## SICHERHEITSMITTEILUNG für Gurtzeuge

- herausgegeben: 15.03.2013
- Nummer: 02/2013
- Bezug: SERVICE BULLETIN # SPSB 008 Sun Path
- Betroffene Muster: Javelin-Gurtzeuge hergestellt von Jan 2009 bis Febr. 2013

# SERVICE BULLETIN SPSB008

SUBJECT: RELEASE CABLE TRIMMING

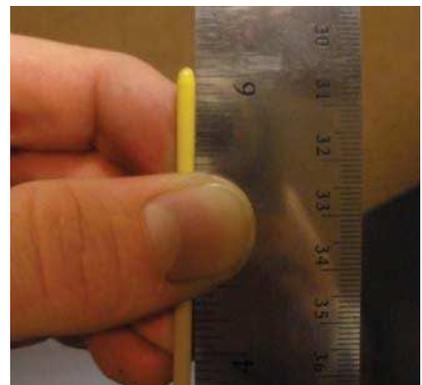
3. Remove any slack in the cables by pulling upward on both sides slightly. (A short tug/or pull on the cable end should take out any slack that may be in the system)
4. Place the rig on the ground or chair and allow the yoke area to relax and ensure your housings are seated/routed as if being worn. Specifically the loop area on the left side behind the main ring cover.

5. NON RSL RISER: Place a ruler with the 0 (zero) at the center point of the grommet on the end of the housing with the numbers running up towards the cable end.
6. Lay the cable out flat against the ruler and record dimension from center of grommet to the end of the cable. Record your measurement and riser side (NON RSL = XX).

7. RSL RISER: Place a ruler with the 0 (zero) at the center point of the grommet on the end of the housing with the numbers running up towards the cable end.
8. Lay the cable out flat against the ruler and record dimension from center of grommet to the end of the cable. Record your measurement and riser side (RSL = XX).
